Architects Supplemental Instruction (ASI)

Project: West Birch Apartments and Townhomes	ASI #: 01
Owner: West Birch Estates of Princeton	Date of Issuance: 09/26/19
To: Lumber One Avon	Architect's project #: 616-18

The intent of this ASI is to amend the Project Documents to incorporate various VE items which were unintentionally omitted in previous document revisions. It is not expected that any of the included items will have any impact on current Project Pricing.

ENLARGED PLANS - UNIT
TYPES E (ACC) & C.2 (ACC)

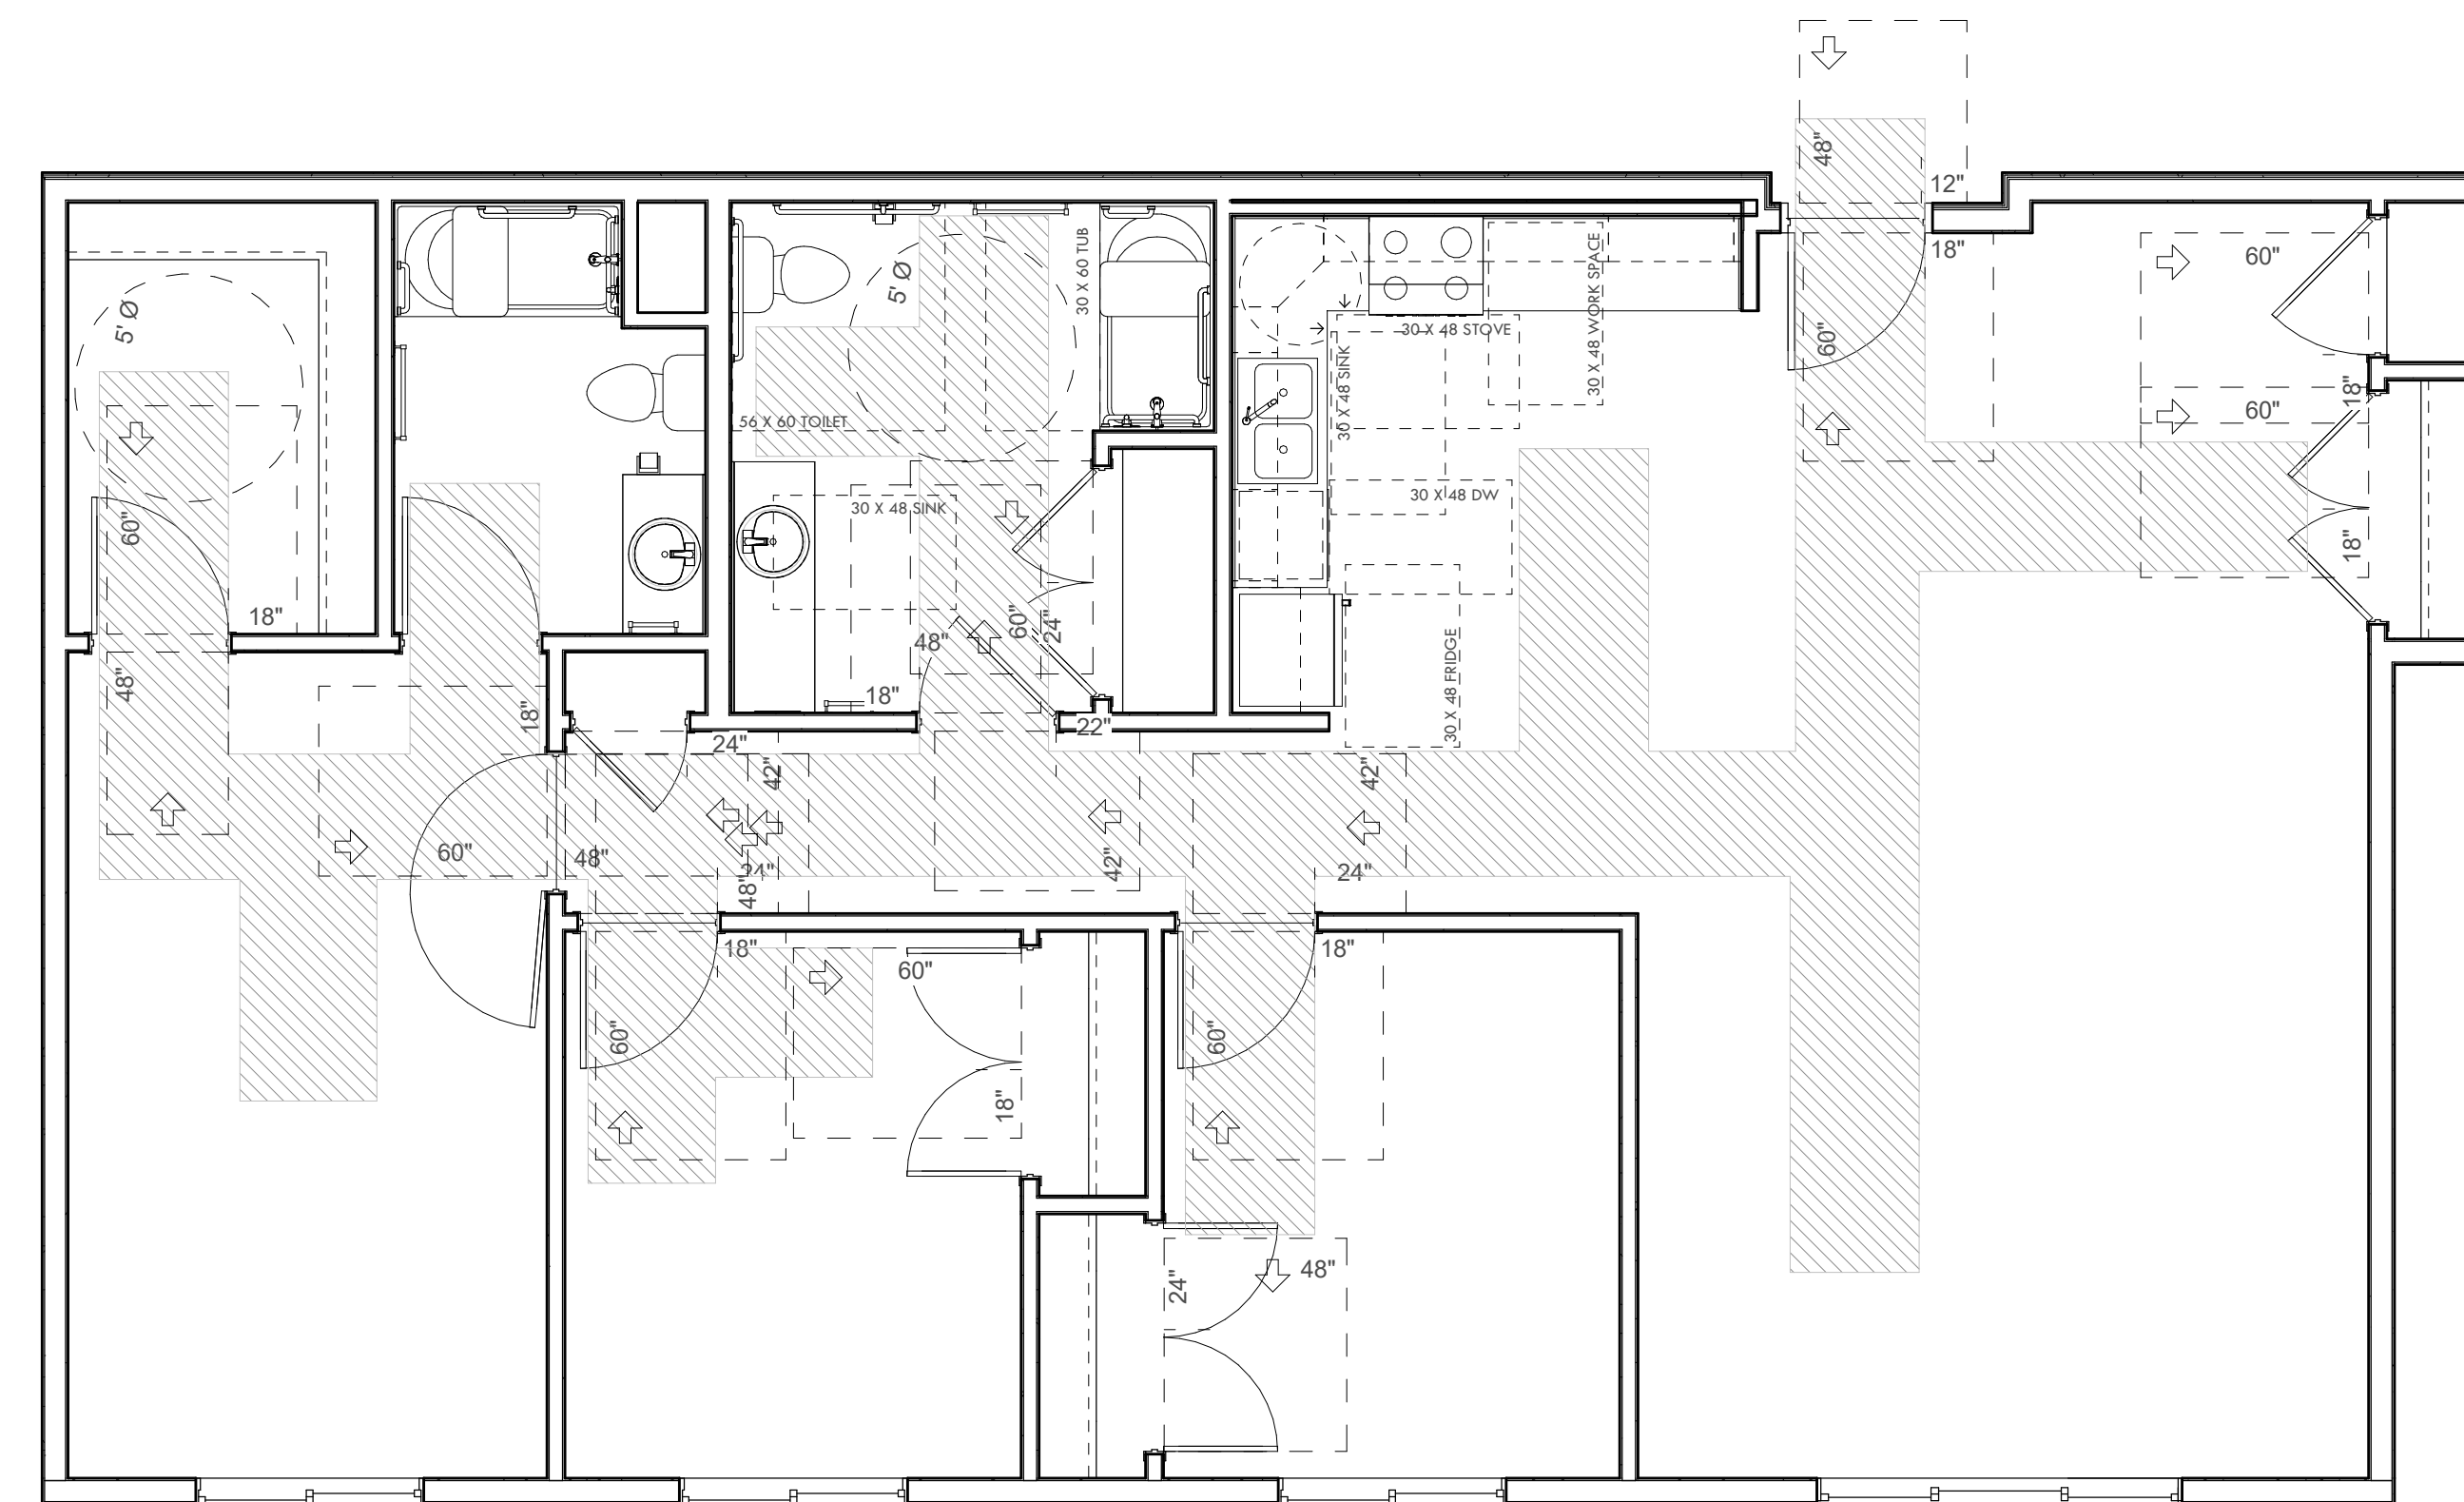
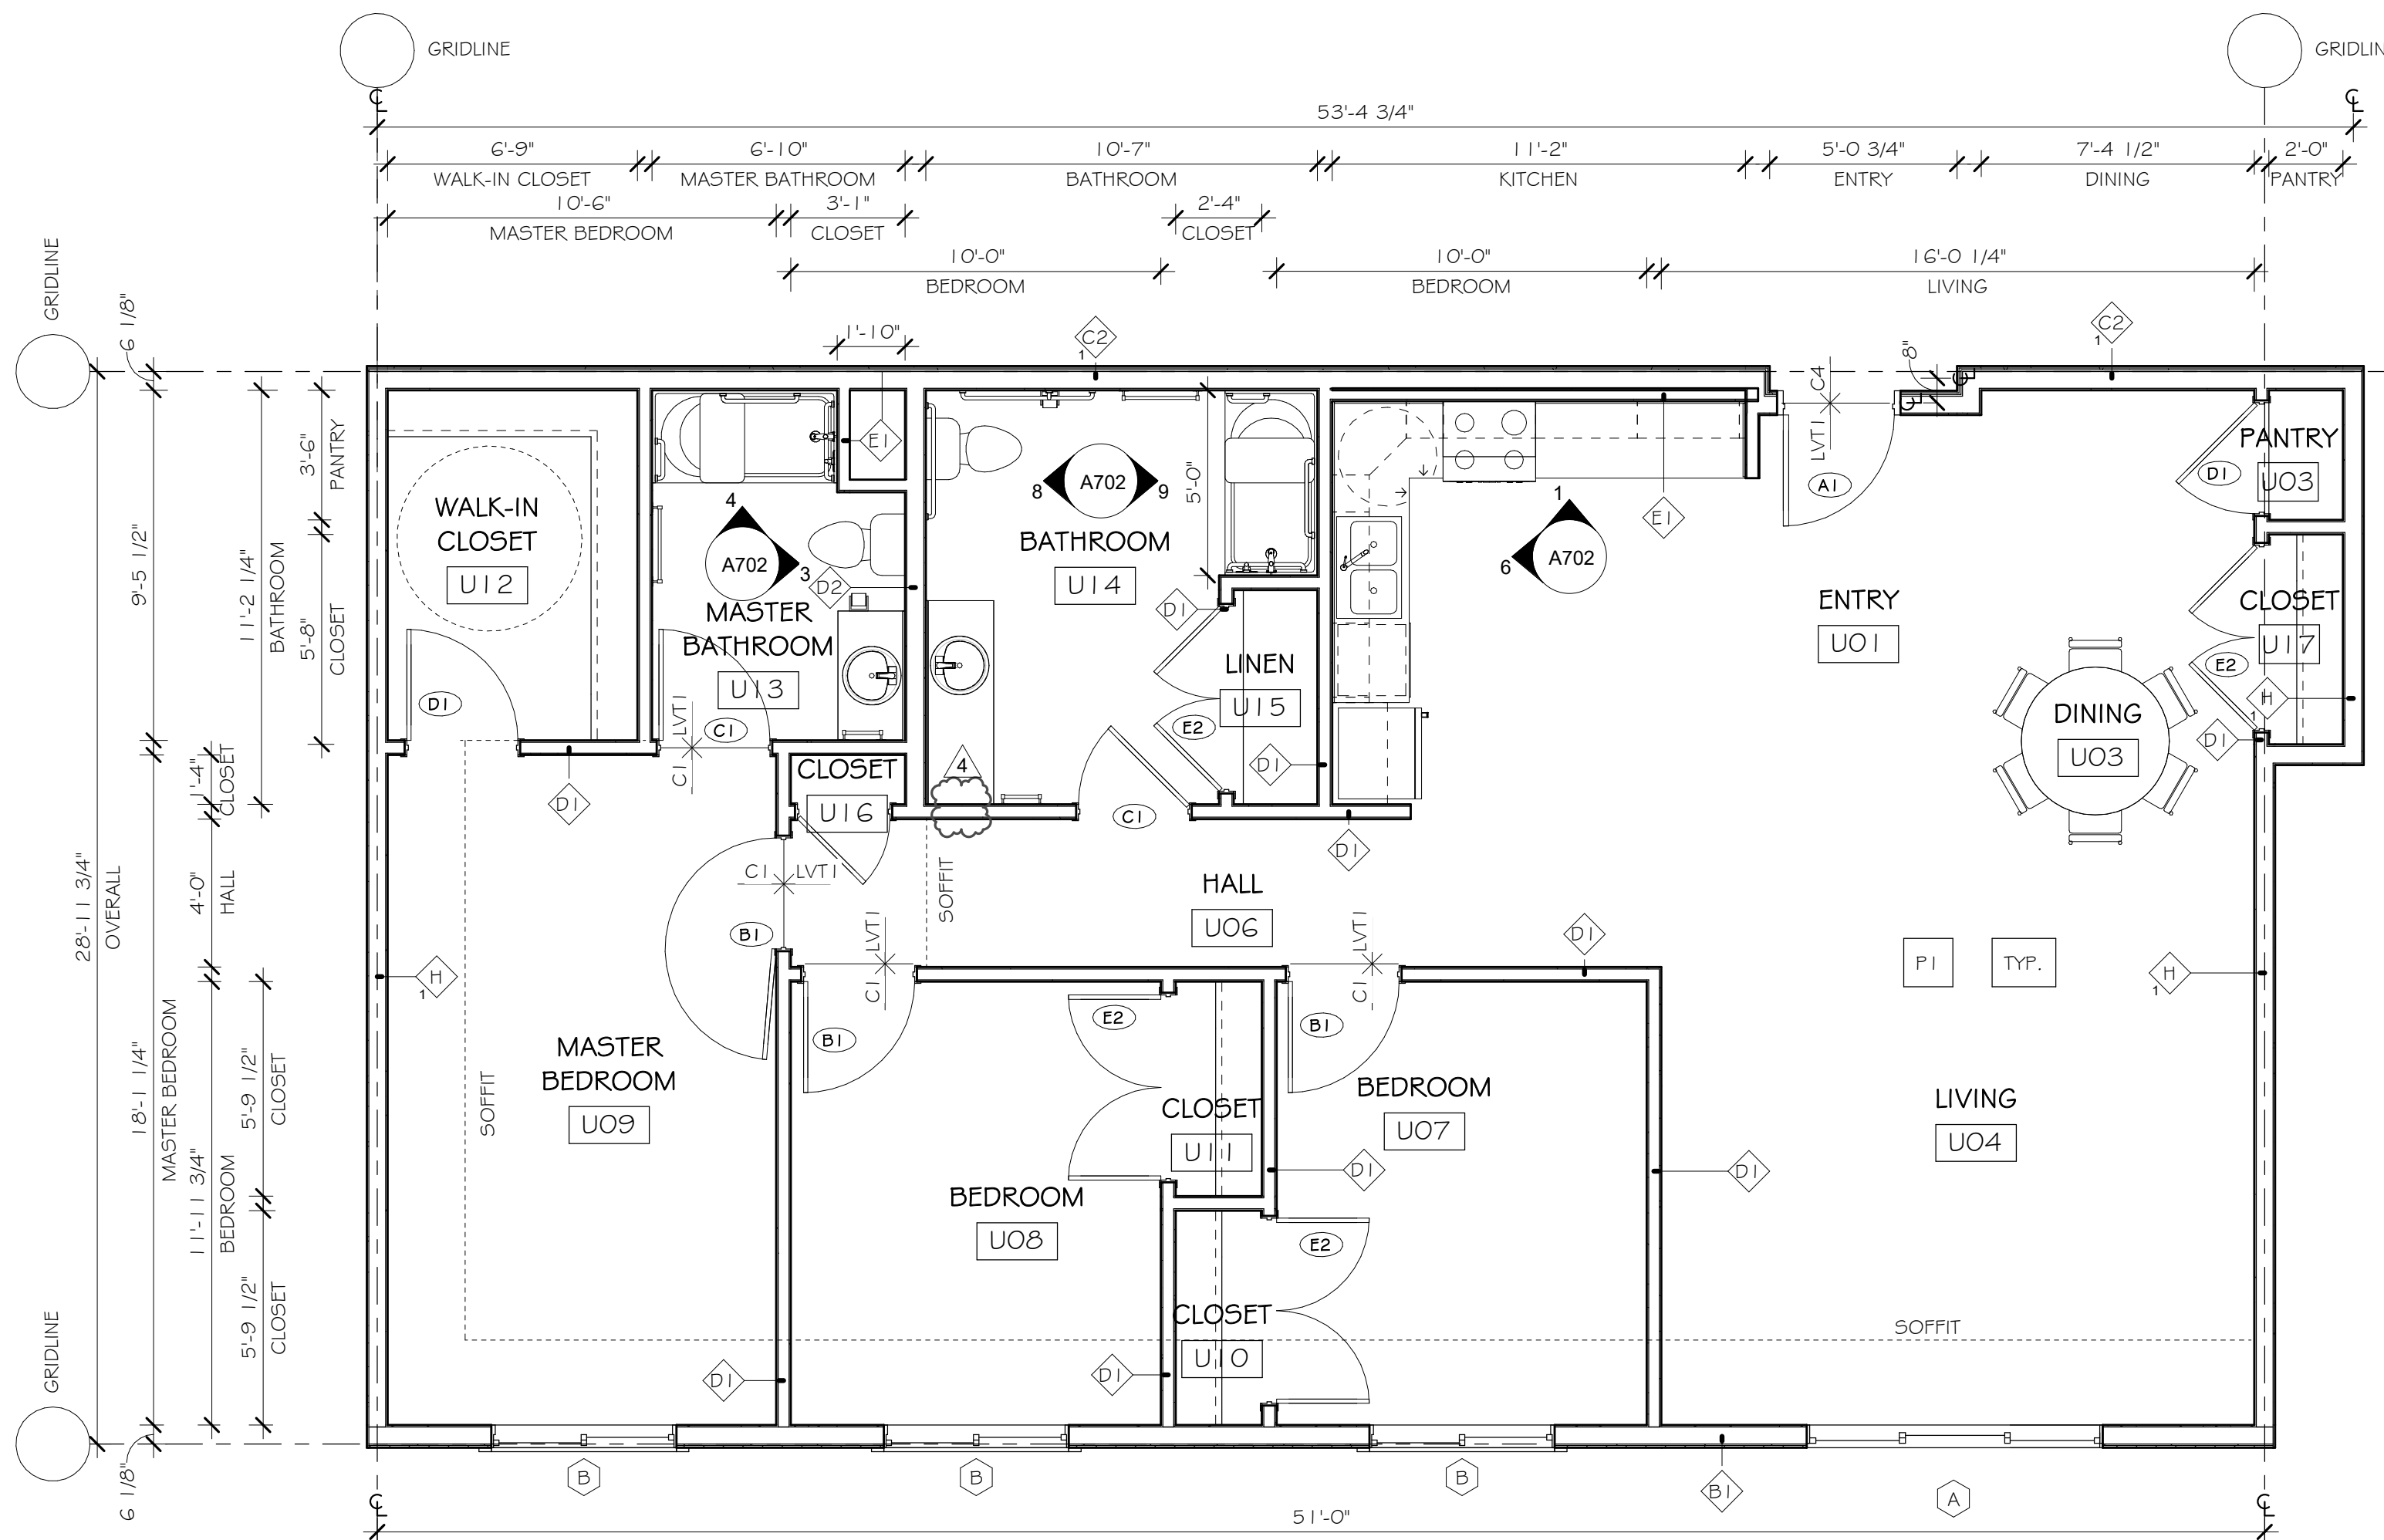
1. Removed text notes referring to cellular PVC trim and replaced them with text notes referring to steel clad trim. Refer to the following sheets (Attached):
 - a. Sheet A310 – Wall Section – detail 2/A310
 - b. Sheet A602 – Exterior Details – Detail 3/A602
 - c. Sheet A603 – Exterior Details at Openings – 2/A603, 4/603
2. Removed medicine cabinets. Refer to the following sheets (Attached):
 - a. Sheet A410 – Enlarged Plans – Unit Types A, A.1, B, & F - Detail 1/A410, 2/A410, 3/A410
 - b. Sheet A411 - Enlarged Plans – Unit Types C, C.1 & D – 1/A411, 2/A411
 - c. Sheet A412 - Enlarged Plans – Unit Types E (ACC) & C.2 (ACC) – 2/A412, 4/A412
